A1 Birtley to Coal House

Applicant's Responses to ExA's Second Written Questions - Appendix 2.0E - Structure Options Report 11 - PCF Stage 3 - Allerdene Viaduct

**PCF Stage 3 – Allerdene Viaduct
Structure Option Report No.11**

Safety Engineering & Standards (SES) Record Sheet					
Scheme Name:	Birtley to Coal House Scheme – PCF Stage 3 – Allerdene Viaduct	<u>Comments Sheet Document Control</u>			
		Comment sheet version	Date HA comment sheet	Date Designer's reply sent	Notes
Document Ref	HE551462-WSP-SBR-S3-BR010-X-RP-CB-00001-P01.2	A	25/01/2019	22/03/19 Updated Response 28/03/19	
		B			
AIP version		C			
		D			
AIP Date	19 December 2018	E

Drawing Title: **ALLERDENE VIADUCT
OUTLINE GENERAL ARRANGEMENT
SIX SPAN OPTION (SHEET 1 OF 4)**

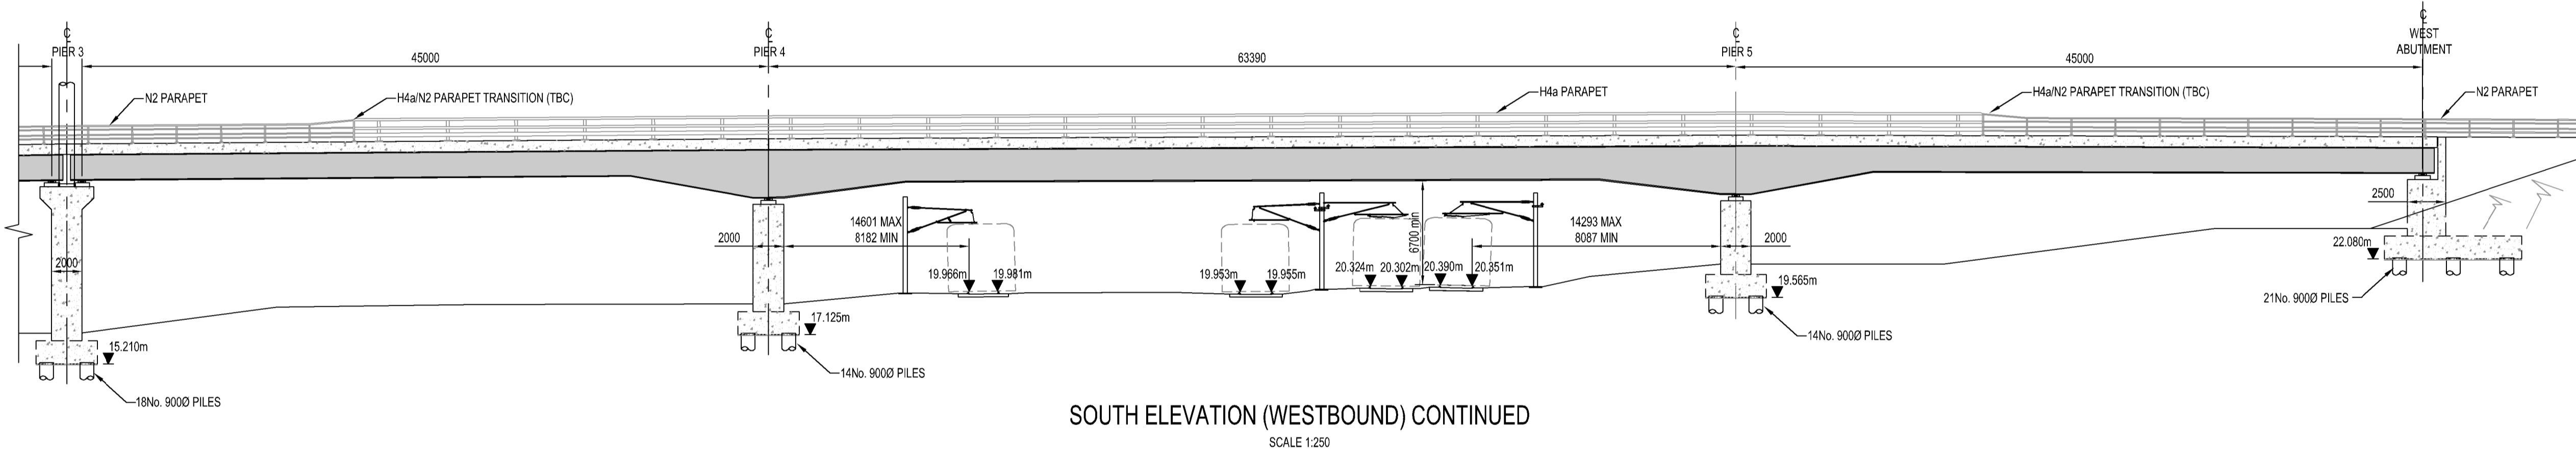
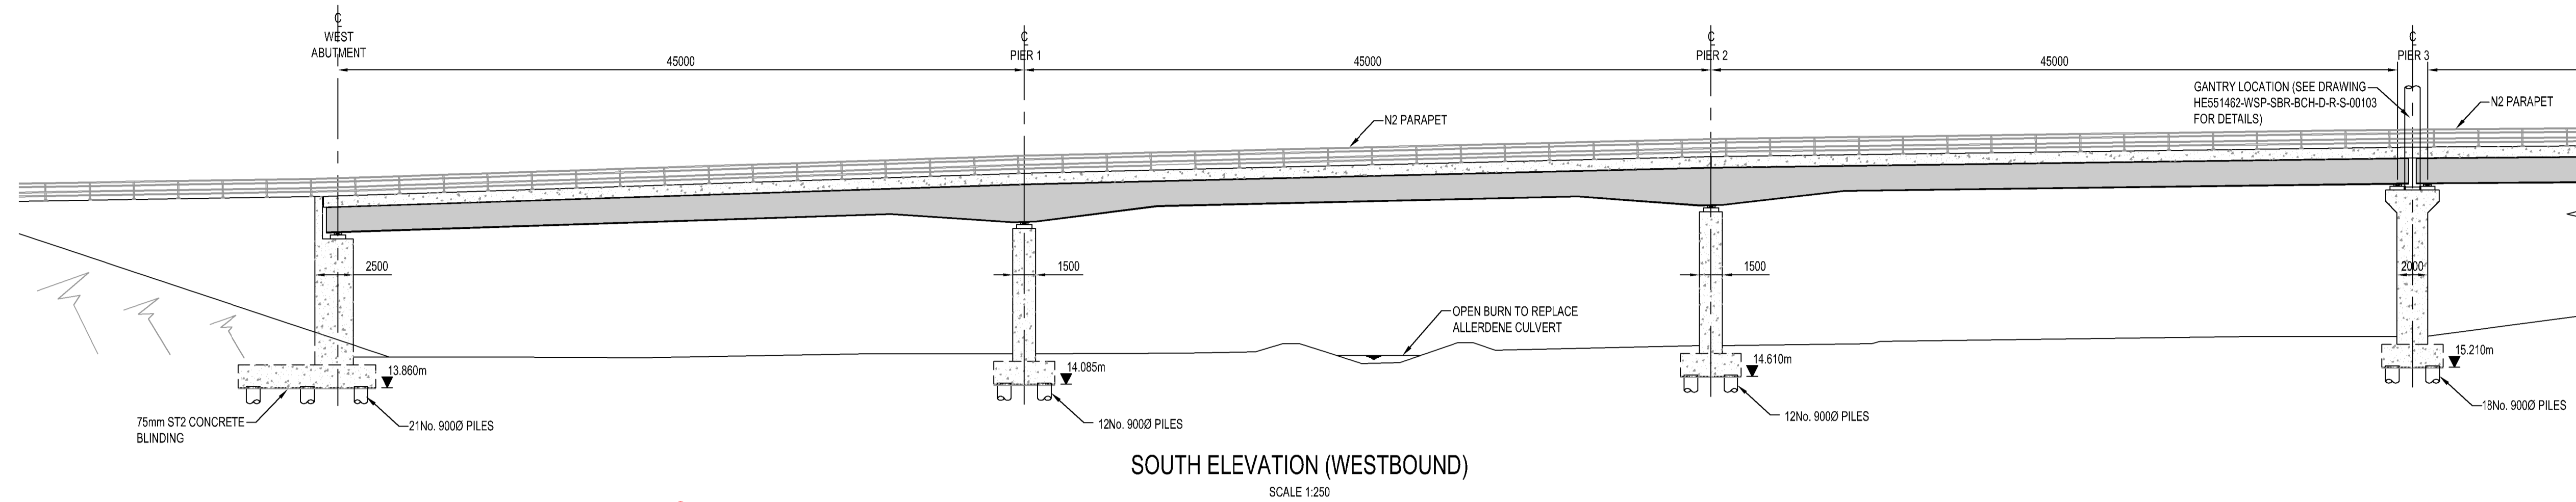
50	Appendix E – drawing 102	<p>Why some of the piers are encroaching onto ECML East land boundary? The substructures should be offset from the track to allow green zone working.</p> <p>Why is the span over ECML longer than for the single span option?</p>	<p>The span and position of supports are such that the vertical clearance to the rail line can be maintained whilst limiting the construction depth and size of girders to within manageable limits regarding logistics and installation.</p> <p>Whilst the piers are encroaching ECML land they are considered to have sufficient lateral clearance from the nearest running rail to allow for a temporary fence line to be constructed to facilitate access/construction outside of possessions. The construction sequence shall be reviewed in further at detailed design stage.</p> <p>The clear span is similar for both options.</p> <p>27/03/19 Clarification provided in response no change to the dwg.</p>

51	Appendix E – drawing 102	<p>Note 5 – for NWR interface, this should have already been done for single span option?</p> <p>Note 6 - see comments regarding total weight and lifting.</p>	<p>There has been some consultation but expect further discussion will be required during detailed design. See previous response regarding total weight and lifting</p> <p>27/03/19 Clarification provided in response no change to the dwg.</p>	
52	Appendix E – drawing 102	<p>Specific notes – “The existing Allerdene Bridge Lanes can be closed..” why any of the lanes over the existing bridge need to be closed? The tie-in works are away from either end. Is it to allow construction plant movement? Similar note is included in the construction sequence.</p>	<p>The construction sequence has been development based on high level consultation with the support contractor Morgan Sindall.</p> <p>The construction sequence shall be finalised during the detailed design phase.</p> <p>27/03/19 Clarification provided in response no change to the dwg.</p>

53	Appendix E – drawing 102	Construction sequence – stage 5. Is WSP referring to Form 01 of Form A? Is this referring to NWR TAA? Please clarify.	<p>Form A is the correct reference for the OLE AIP document</p> <p>27/03/19 Clarification provided in response no change required to the dwg.</p>	
54	Appendix E – drawing 102	<p>Stage 12 - position of the crane to be confirmed. If this has not been done already, please confirm it a.s.a.p including crane capacity or else WSP is risking proposing non-buildable solution. This is risk that should have been shown on the drawing including that of interface with NWR (track movement etc) and lack of GDR.</p> <p>Stage 13 suggests GRP attached after steel beams in place – this contradicts other sections – please make consistent</p> <p>Stage 19 – this is steel composite deck not RC deck. This will affect proposed demolition sequence (no crash mat but rather lifting of the beams). Please amend.</p> <p>Stage 20 – what concrete below half joints does it refers to?</p> <p>Stage 22 - can WSP confirm the piers can be removed outside of possession?</p>	<p>The construction sequence has been development based on high level consultation with the support contractor Morgan Sindall.</p> <p>The construction sequence shall be reviewed/finalised during the detailed design phase.</p> <p>27/03/19 No change required to dwg at this stage</p>

Drawing Title: ALLERDENE VIADUCT
OUTLINE GENERAL ARRANGEMENT
SIX SPAN OPTION (SHEET 2 OF 4)

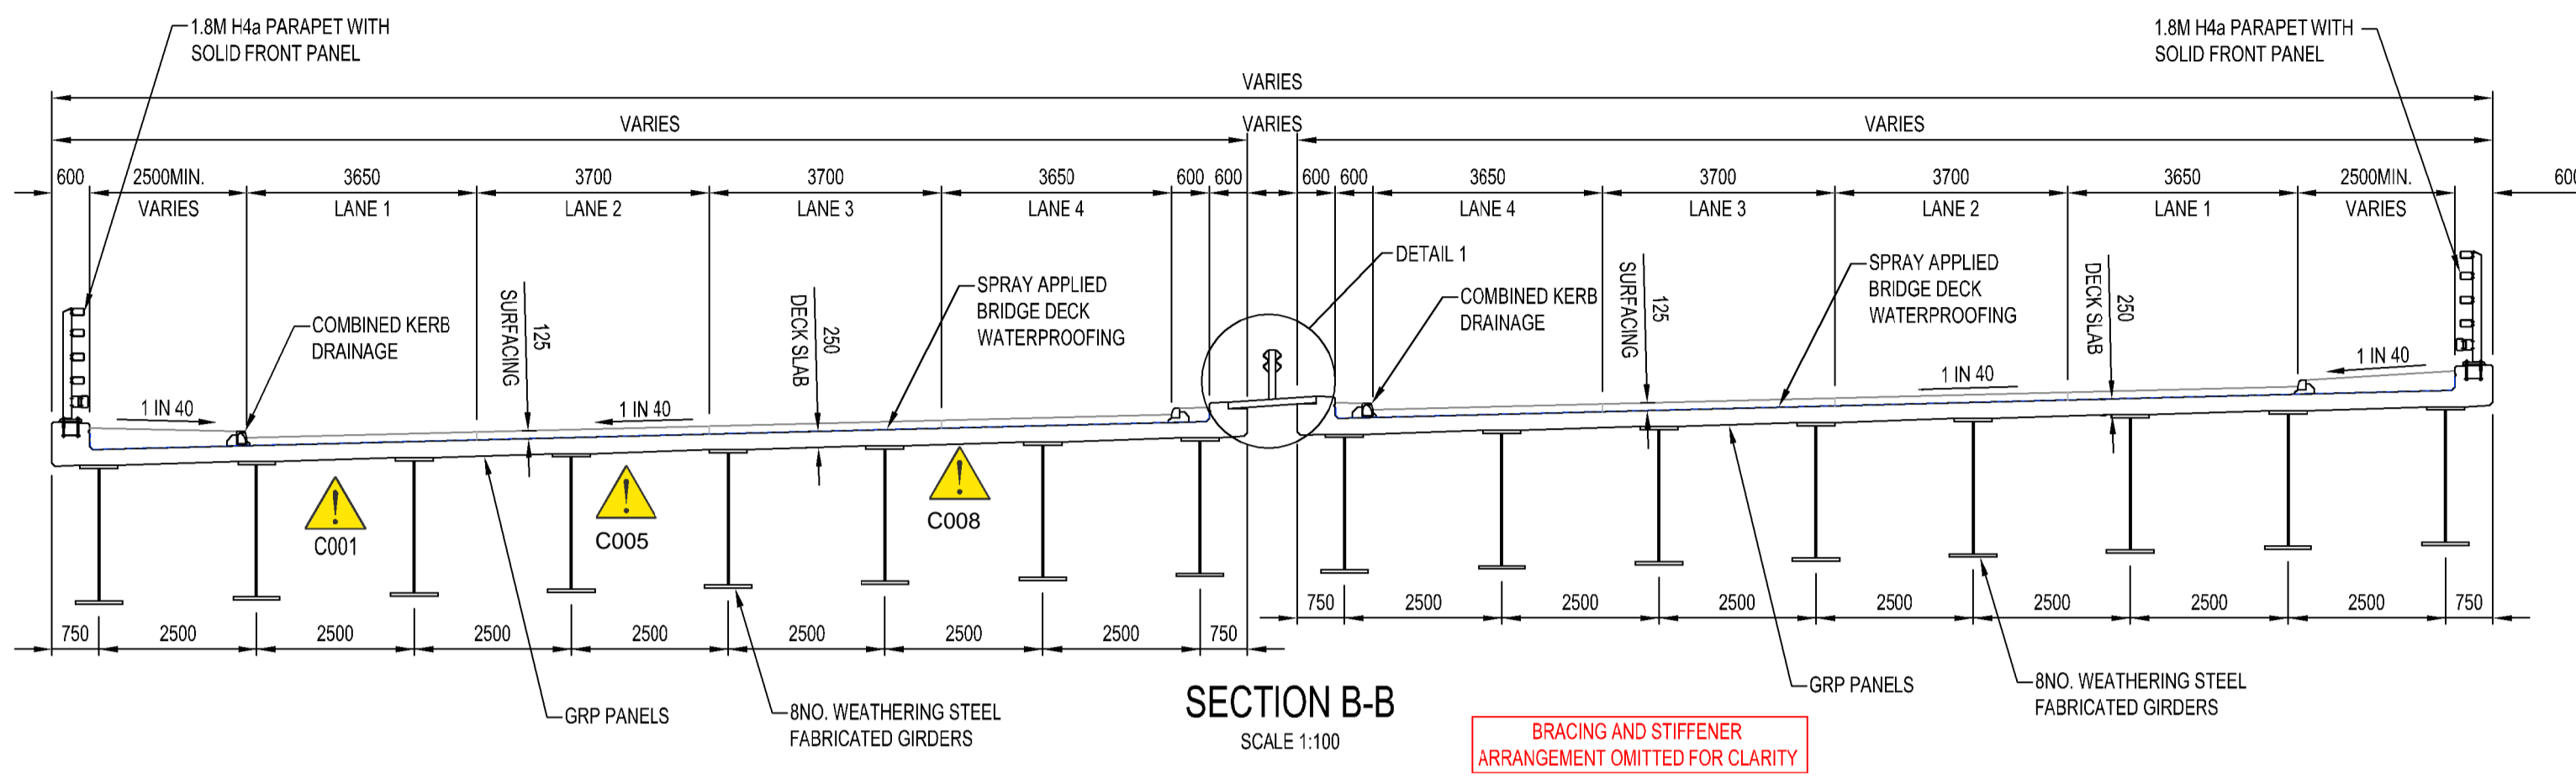
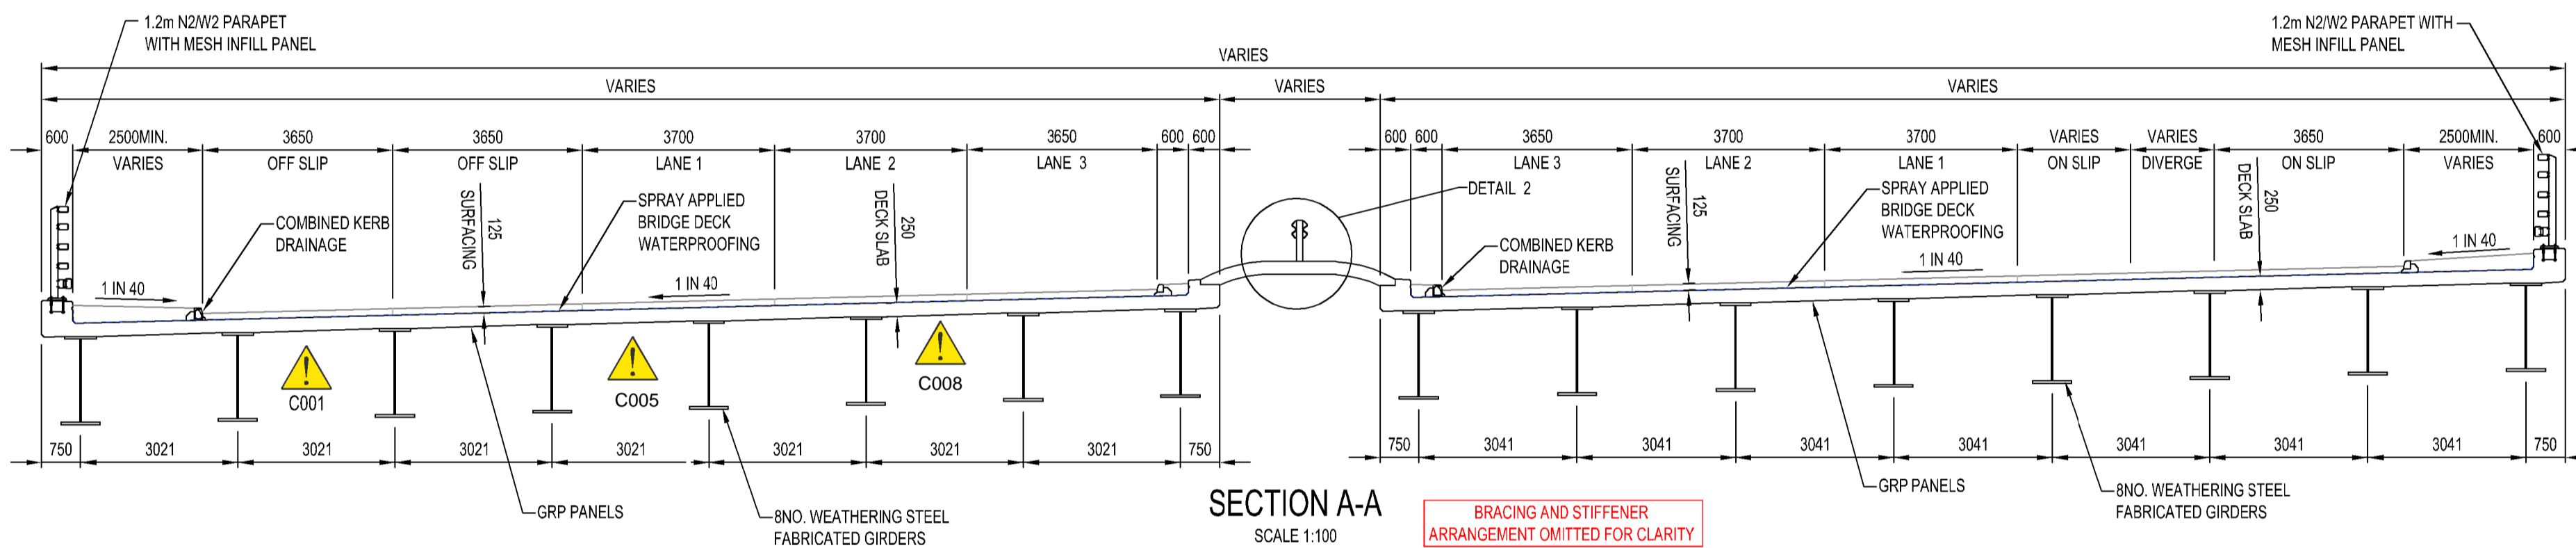
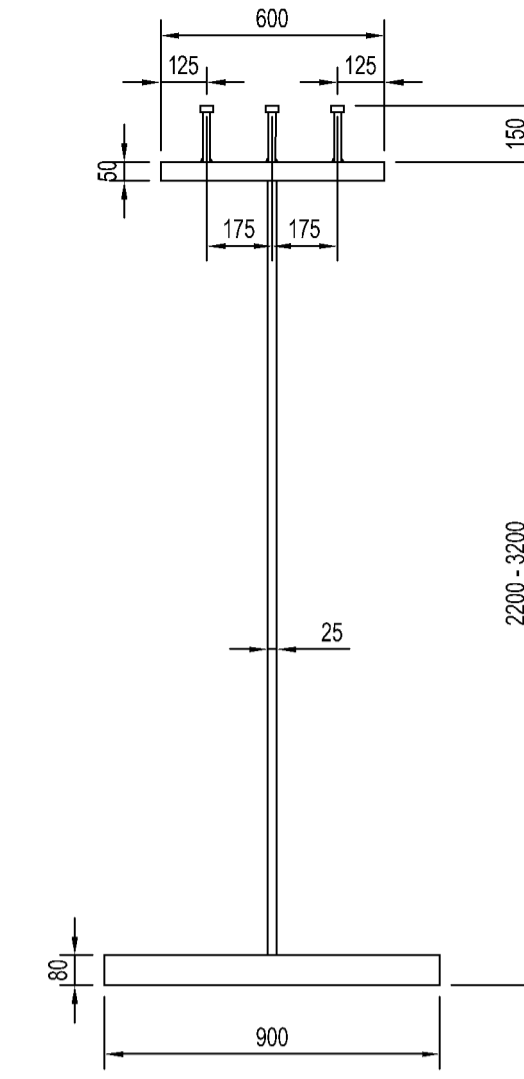
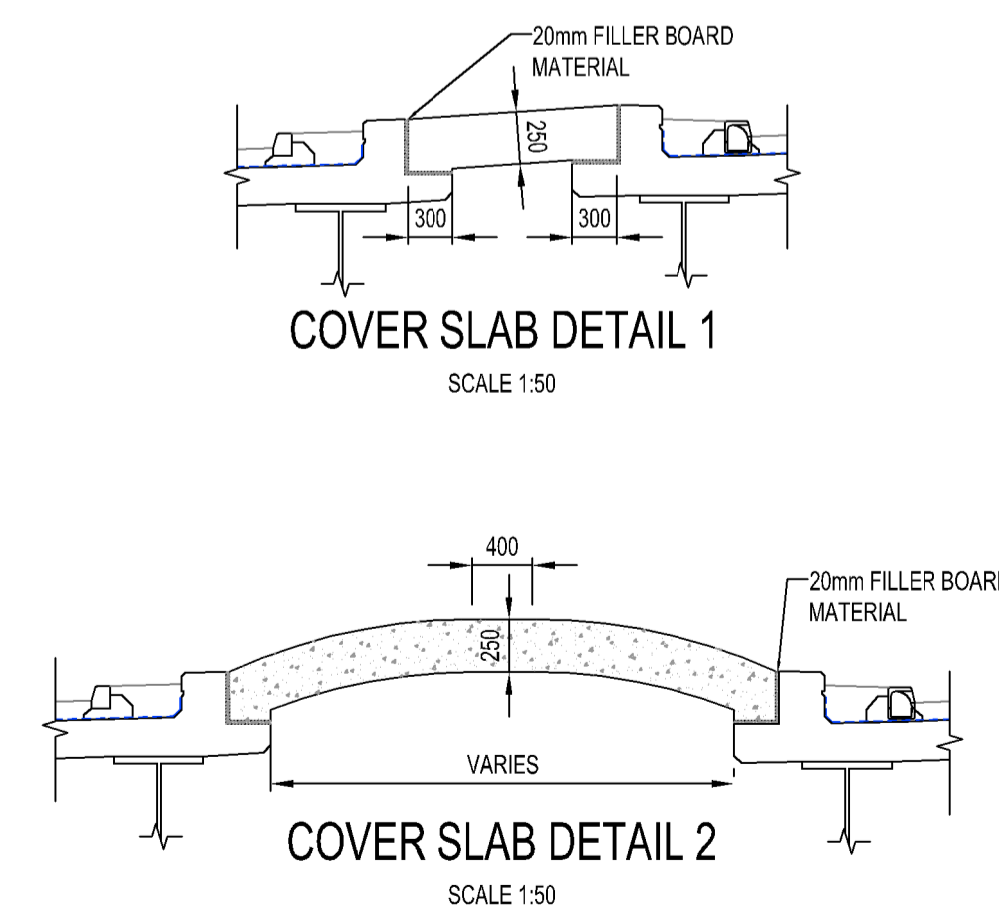
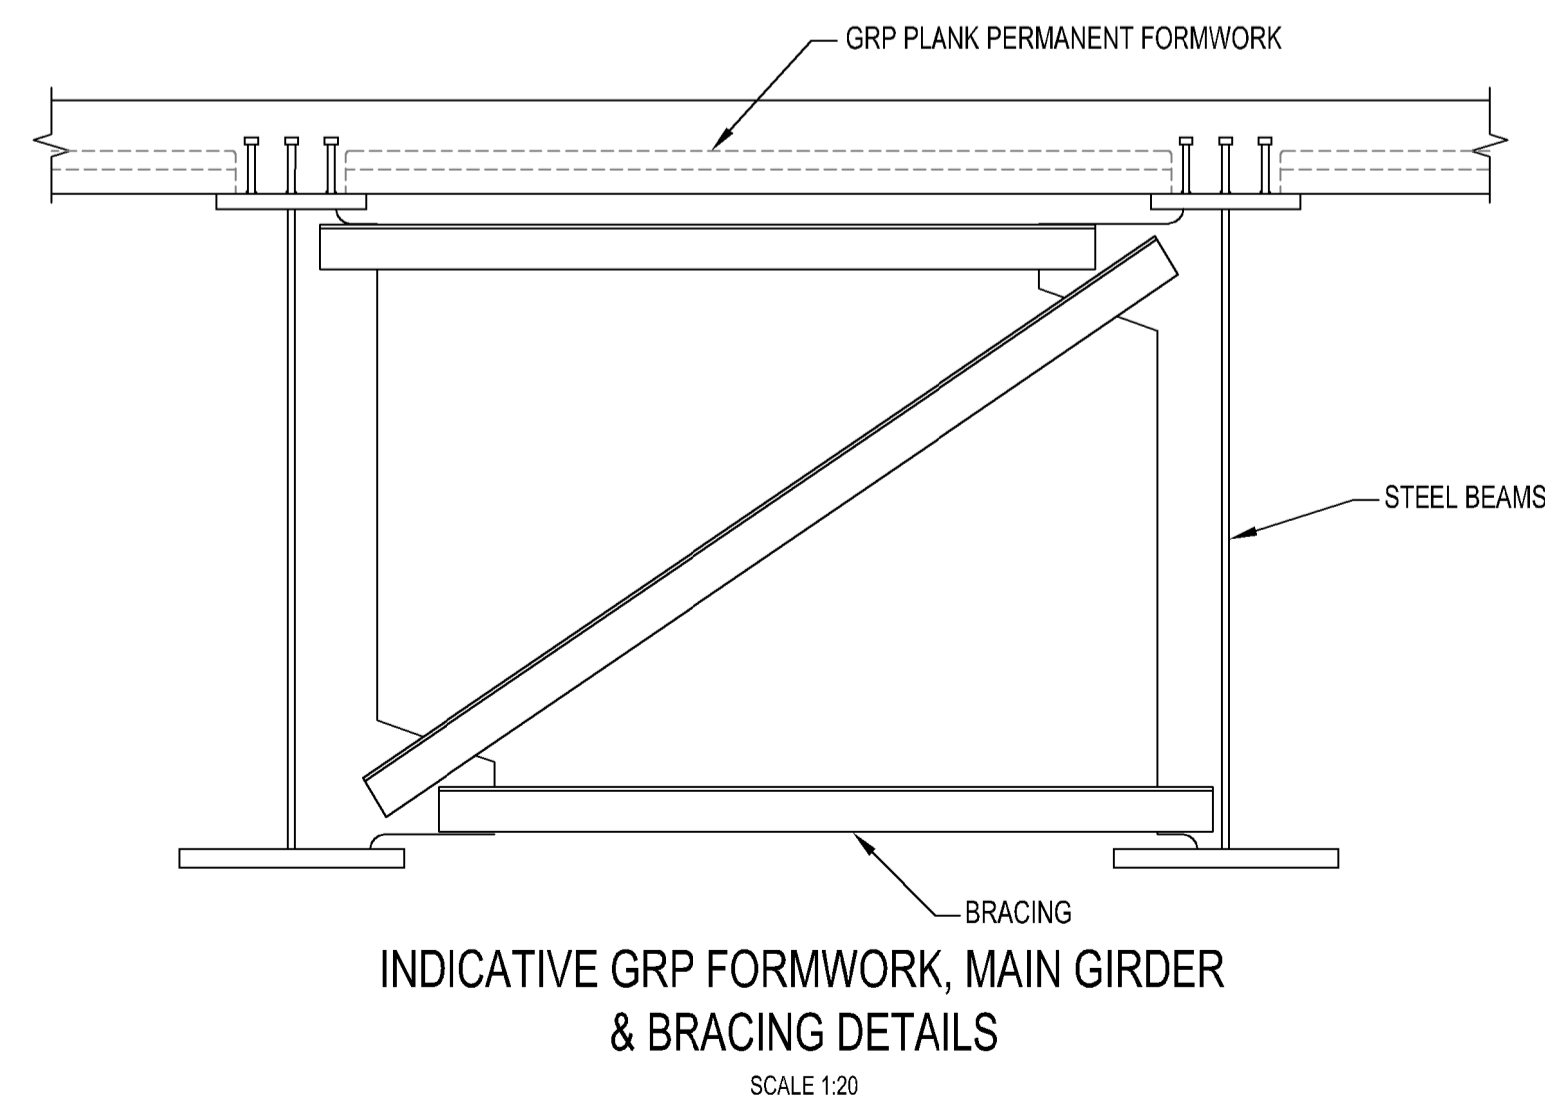
55	Appendix E – drawing 103	<p>Please show anticipated splice position.</p> <p>The parapet over railway does not look like 1.8m h4A solid infill parapet.</p>	<p>Noted, this is an outline general arrangement drawing. Comments shall be communicated to the detailed design delivery partner and addressed at detailed design should the viaduct be the preferred option.</p> <p>27/03/19 No change required to dwg at this stage</p>	
56	Appendix E – drawing 105	<p>Should there not be transverse stiffeners at jacking point locations? Please shown F6 finish to piers.</p>	<p>Noted, this is an outline general arrangement drawing. Comments shall be communicated to the detailed design delivery partner and addressed at detailed design should the viaduct be the preferred option.</p> <p>27/03/19 No change required to dwg at this stage</p>
